WATERS Weekly FPY review (WW43 – 2018)

Agenda

WAT-441001280 (Ethernet Cable, supplier CMTi)

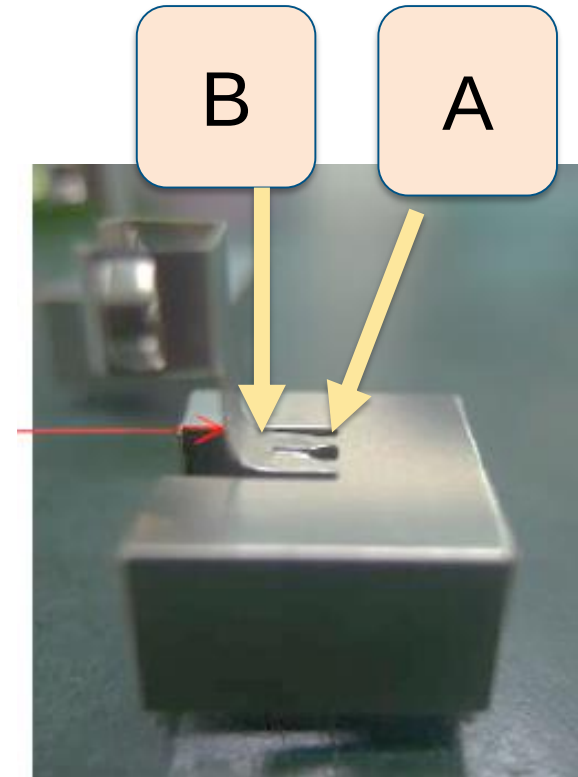
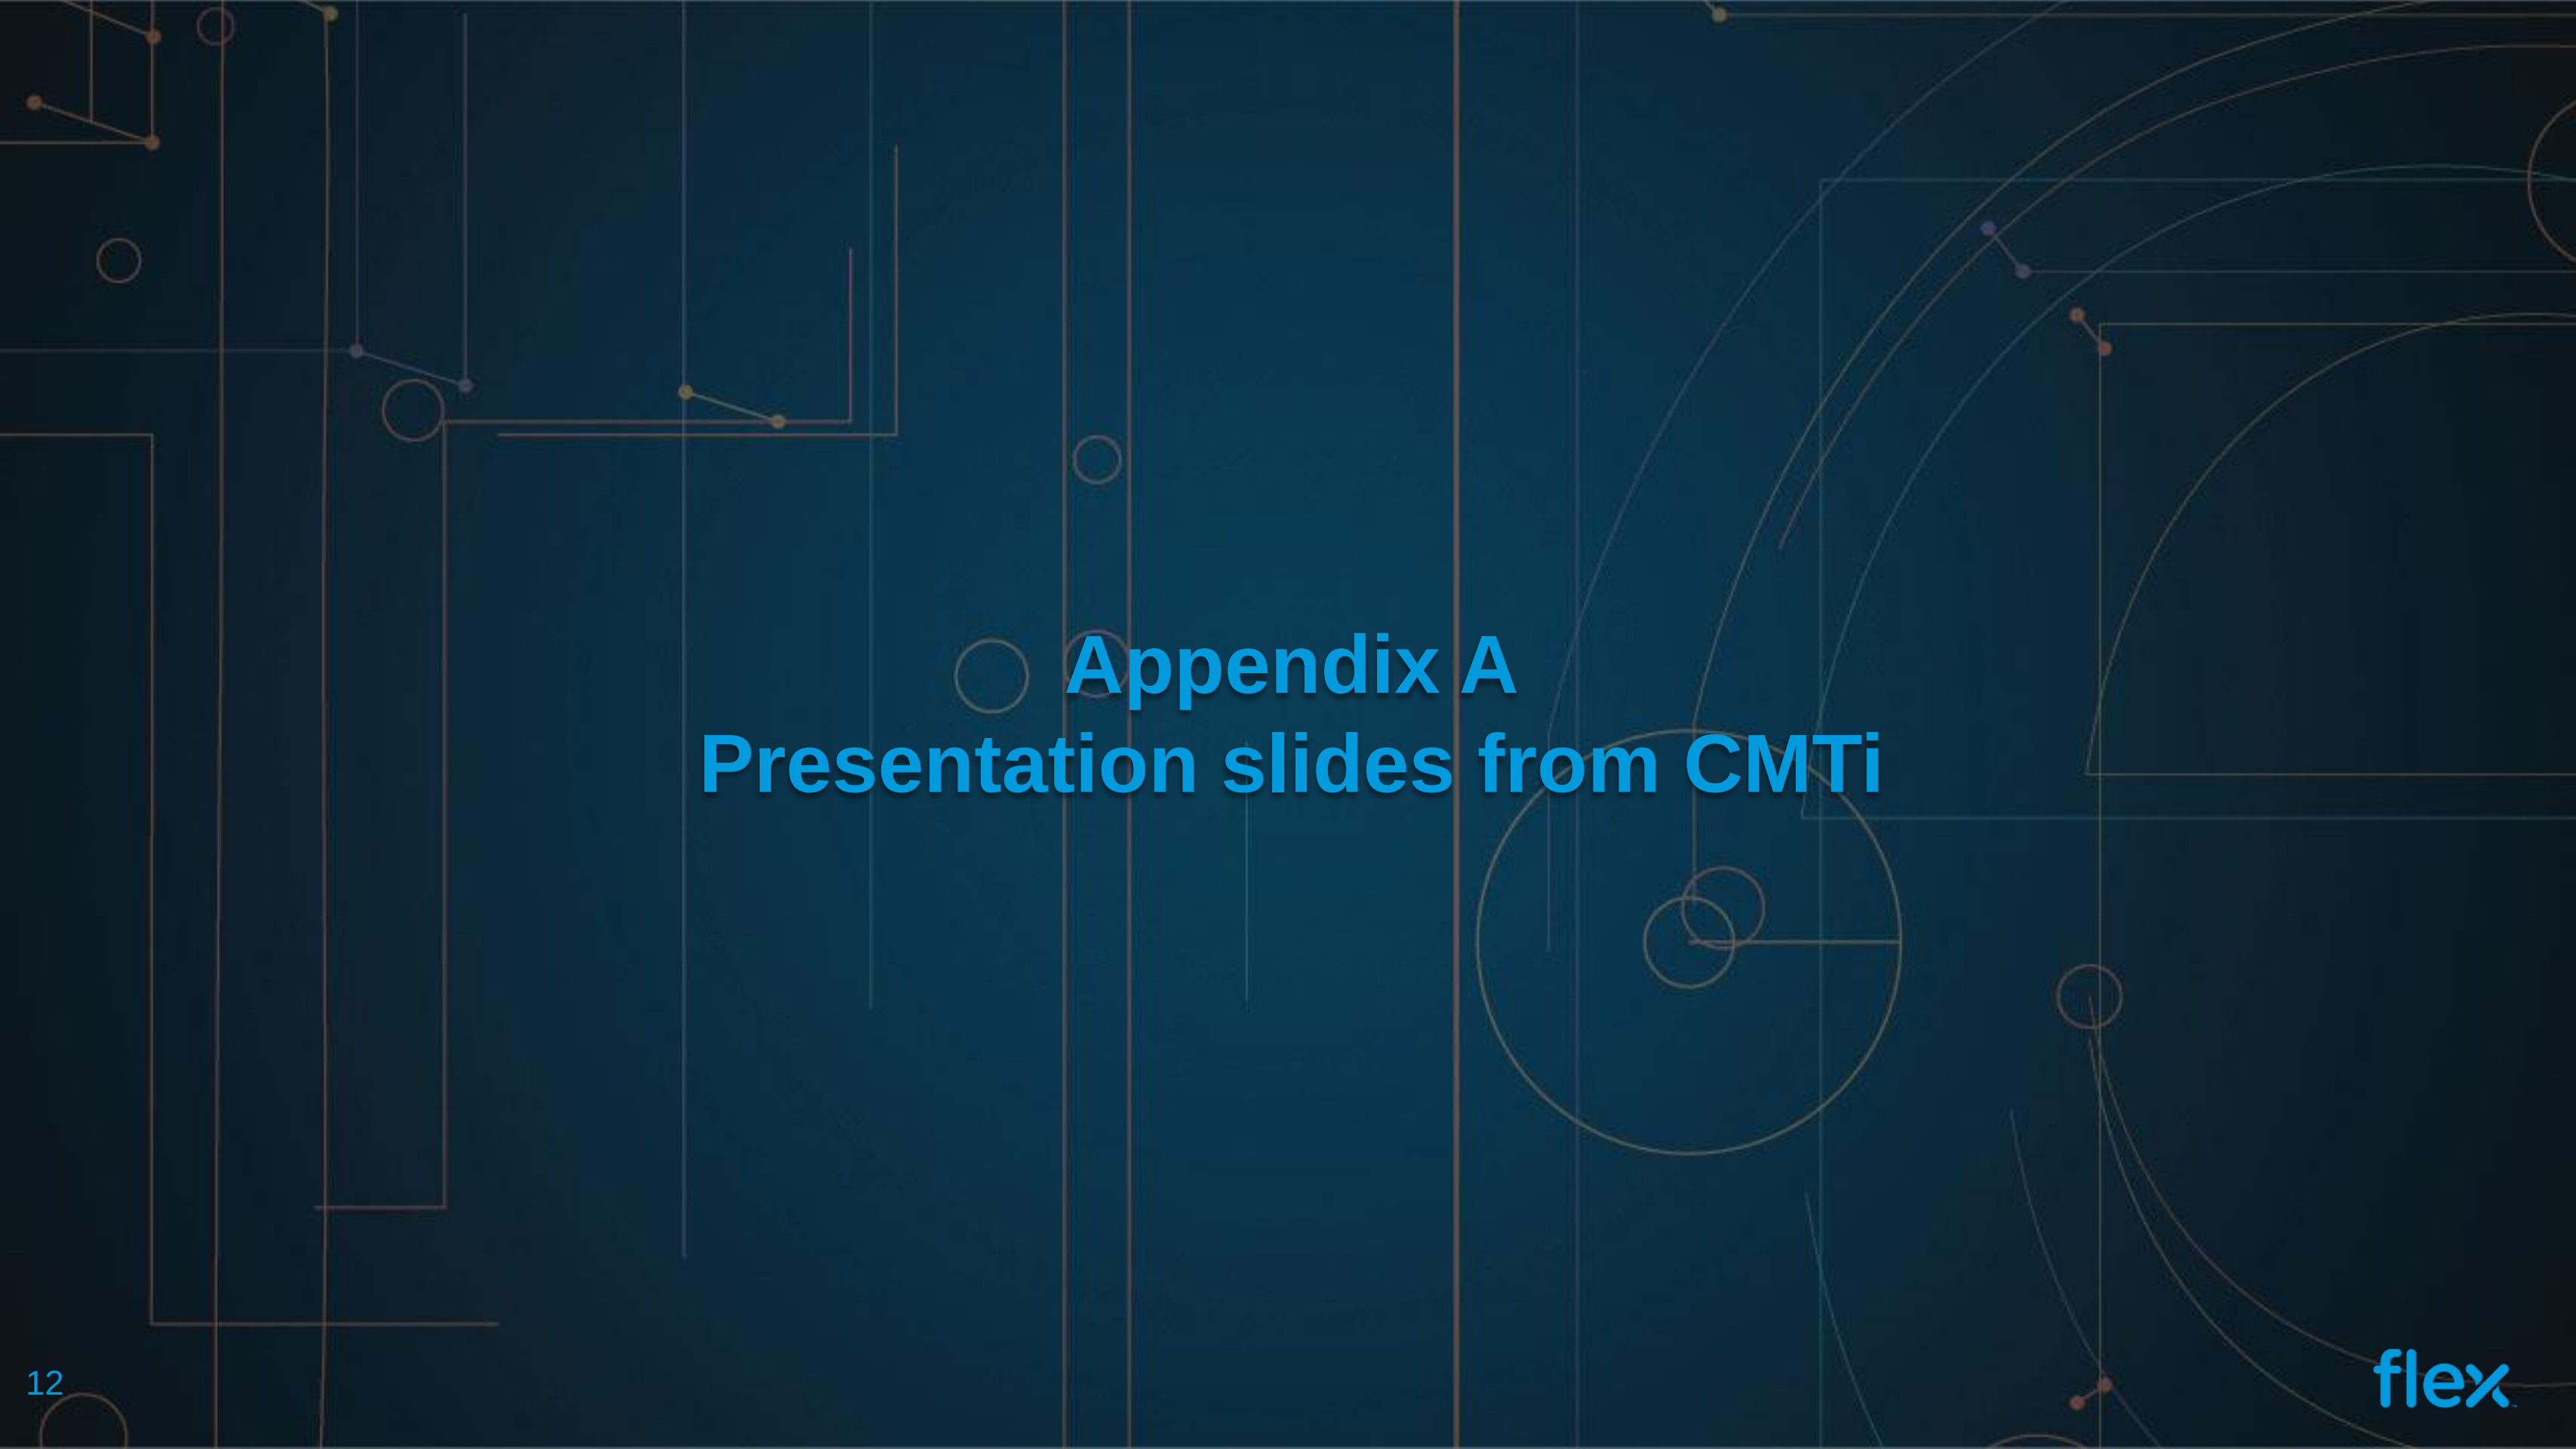
- WW52'18: one instrument (PN 186299800) failed Communication error. Investigation: after replace PN 441001280 (Ethernet Cable), the Instrument has passed.
- Further Investigation: it was found that the Grounding was broken (damaged)

- CMTi reported that there is no failure reported at their outgoing since May 2017 (Qty tested: 9200 pcs)
- CMTi proposed to change the bending point.
- See Appendix A for more detail

- Option A – if we were to proceed with this change, CMTi will have to raise a PCN (Process Change Notice). A small qty for trail is proposed before implementation in mass production.
- Option B – no change is needed. Based on the performance the failure rate is relatively low.

- There is no failure in Feb 2018 and Mar 2018 (Total > 600 instrument build)
- As the occurrence (Ethernet cable failing) is low and random, Flex does not recommend to go ahead with this change (Option A).
- Flex recommends to further monitor the yield and keeping this proposal as an option for future discussion.

Result :

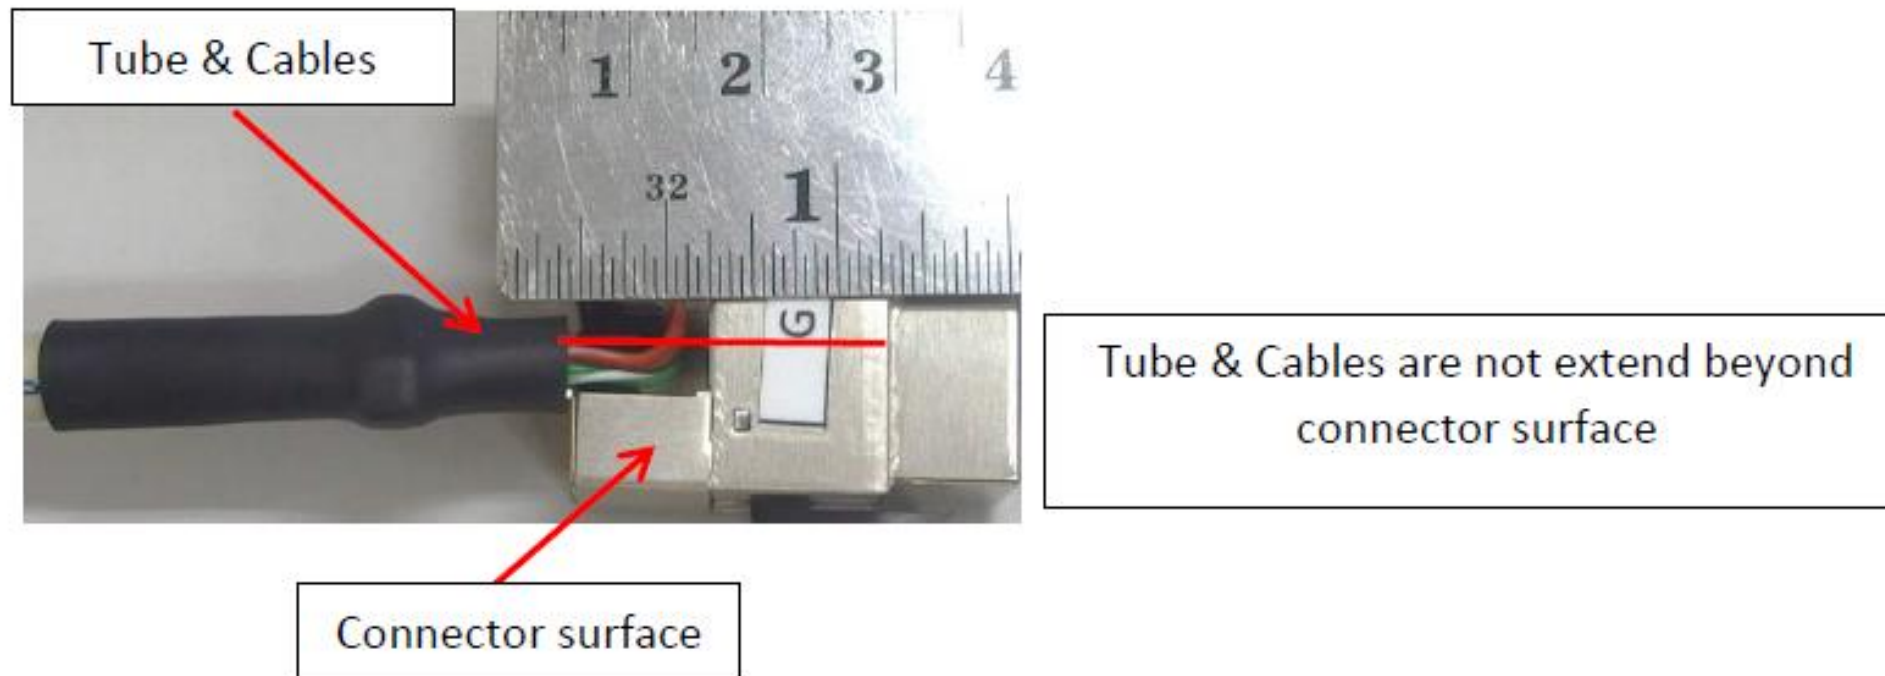
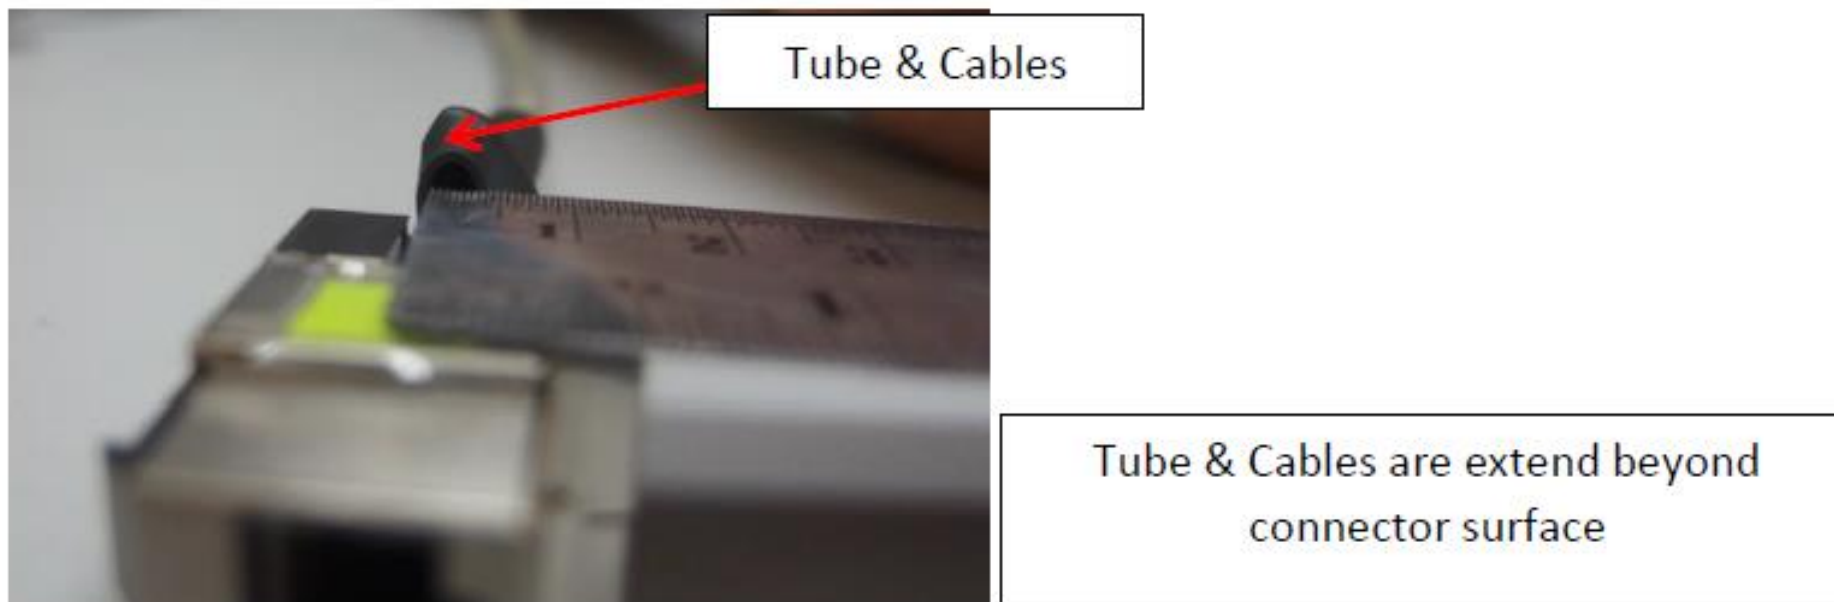
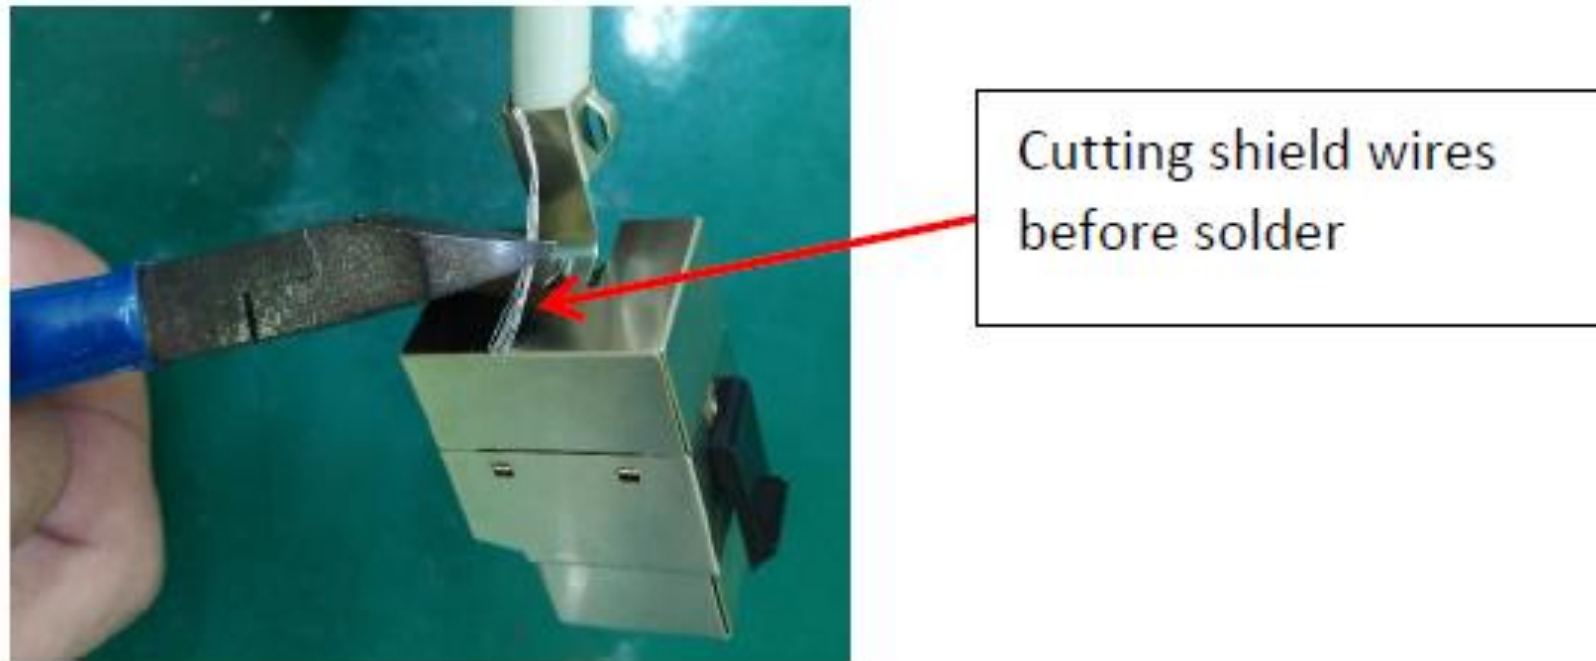
- ✓ Current bending method : Connector broken after 22 times bending
- ✓ Propose bending Method : Connector broken after 64 times bending

1. Propose bending method strength result is better than current bending method
2. Cable position of propose bending method is out of connector surface (refer to below picture for comparison)

3. There's additional cutting process for shield wire before solder to metal shield

4. Total Length of cables might sorter than current bending method. Therefore, we will conduct another simulation with actual product requirements when it's required.

- Propose bending method strength result is better than current bend method
- Cables & tube position are extend beyond connector surface might effect to form, fit
- There has additional cutting process for shield wire before solder
- Next simulation for total length of cables shall study if it's required.

01 Oct 2018 : response from Machine Shop, for info and discussion

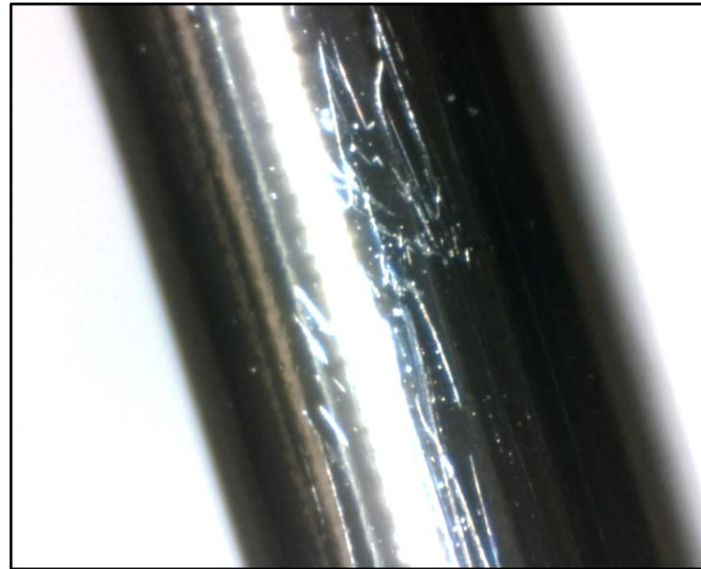
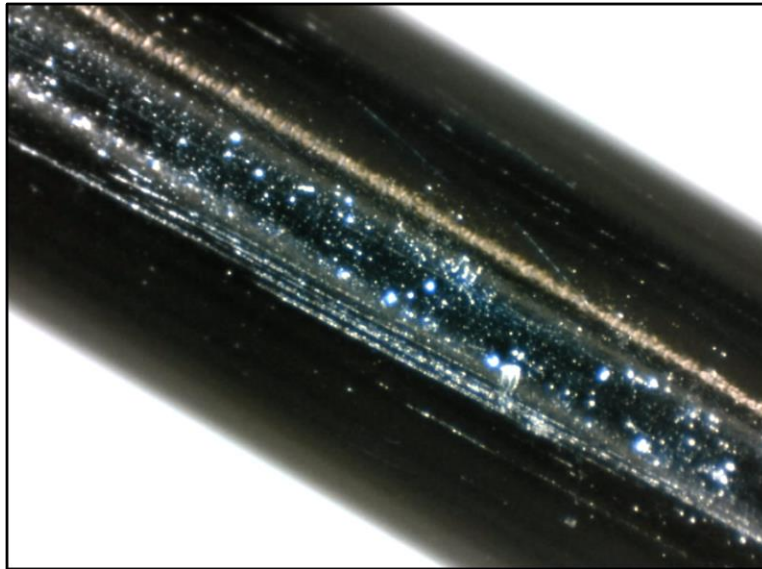
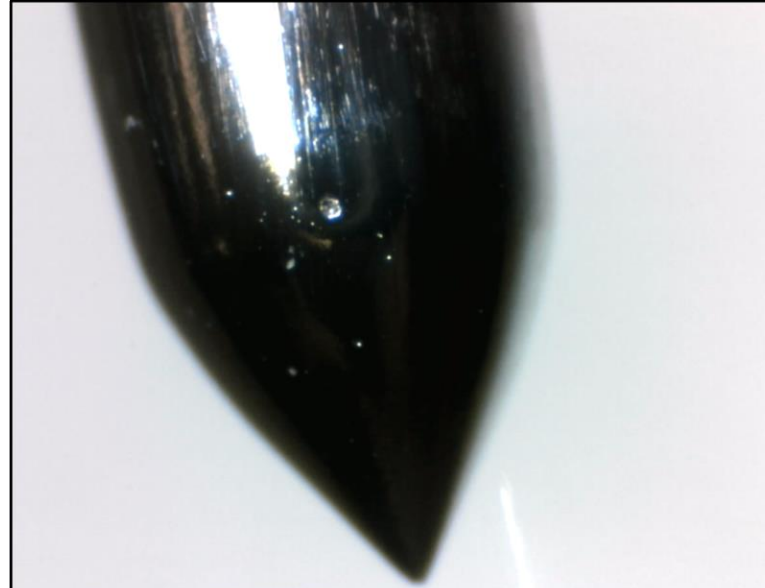
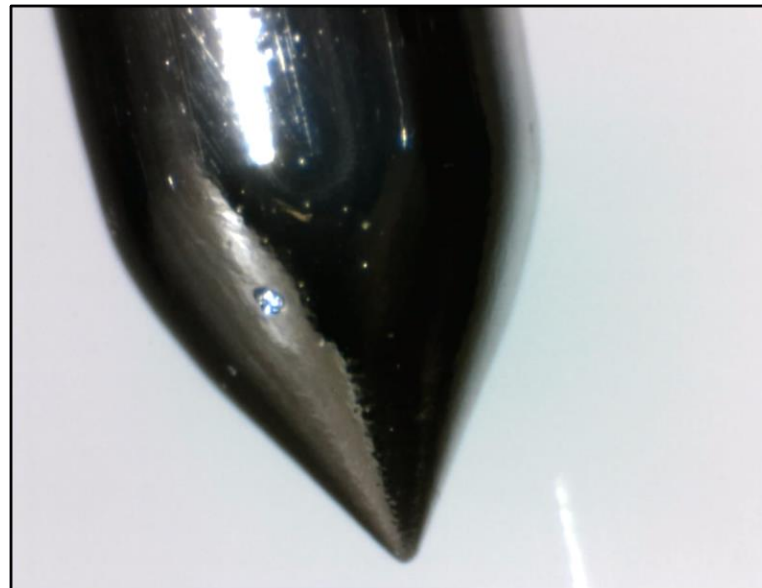
Scratches

Pits

Sample 1 (20x magnification)

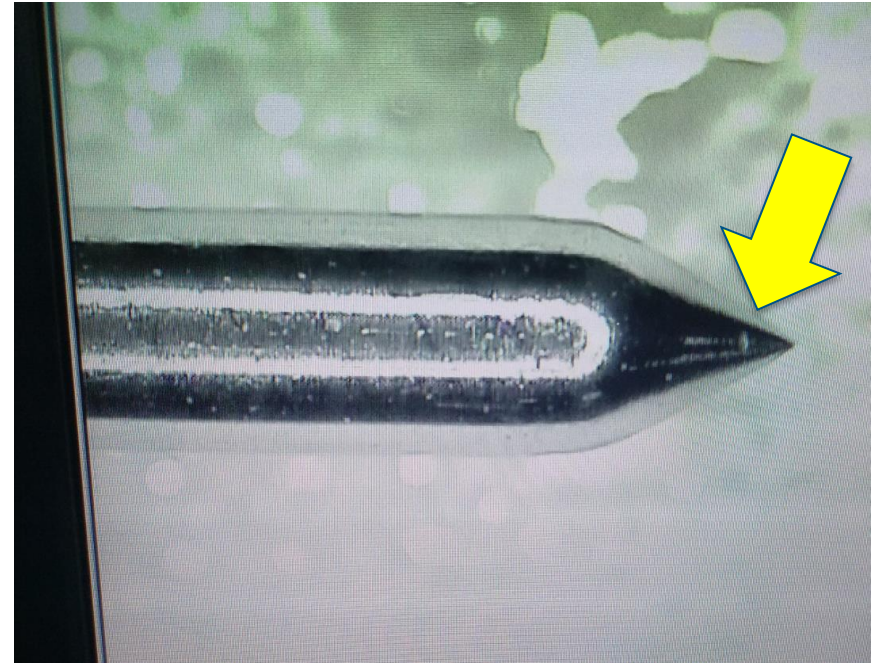
- Needle tip is checked for pit mark. A small pit mark was observed.

- Needle body is also checked for longitudinal scratches. No scratches found.

Sample 2 (20x magnification)

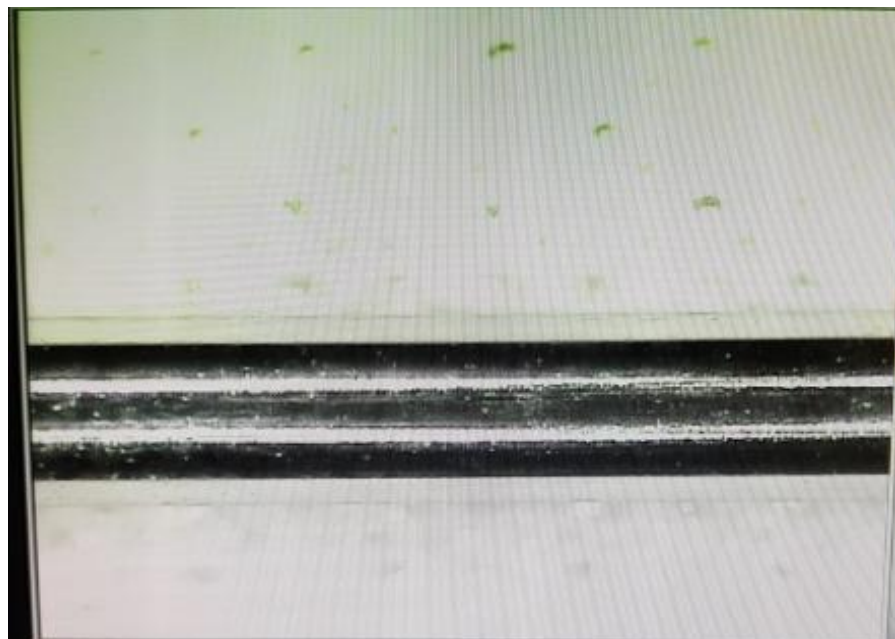
- Needle tip is checked for pit mark Unable to detect pit.

- Needle body is also checked for longitudinal scratches. No scratches found.
